# **RESPONSIVENESS SUMMARY**

# Michigan's Adventure Amusement Groundwater Discharge Permit GW1010335

# SITE MAP 1 & 2

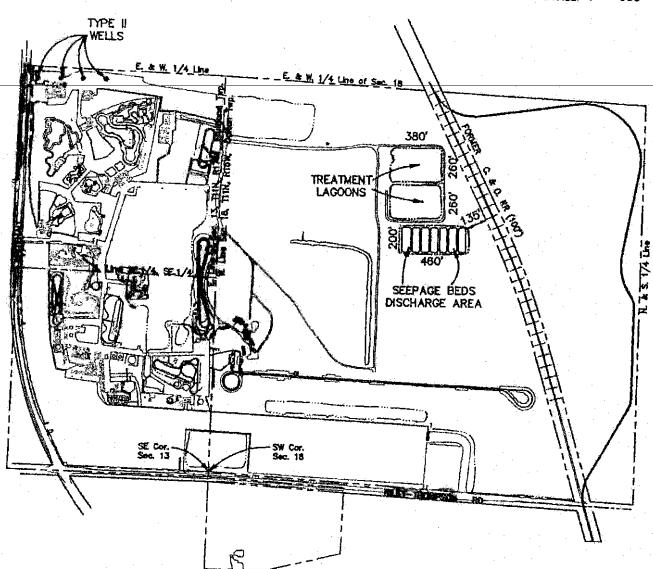
9. Maps contained in the application are not clearly marked as to which is map 1 and map 2, the maps have been copied so the scale is no longer accurate. The maps did not indicate the discharge to Duck Creek. The water usage diagram is missing the required daily average flow rates at influent, intake and discharge points and daily flow rates between treatment units.

**Response:** Maps where reviewed by DEQ staff and between the two maps provided in the application (attached) it was determined that the application requirements were met. The Michigan's Adventure permit application includes a

topographic map that outlines their property with township and county names clearly marked at the top and a north south arrow, offsite surface water and streams. A second map (identified as Site Map 1&2) provides a map of the treatment system, including onsite wells and distances to property lines and surface water. The two maps together provide all the information requested in Section 10 of the groundwater discharge permit application. As noted in Item 2, above, the storm water discharge to Duck Creek is not a groundwater discharge.

The water usage diagram contains sufficient information, in conjunction with the requested daily and annual flows in the application, for the DEQ to determine appropriate limits for flow in the permit.
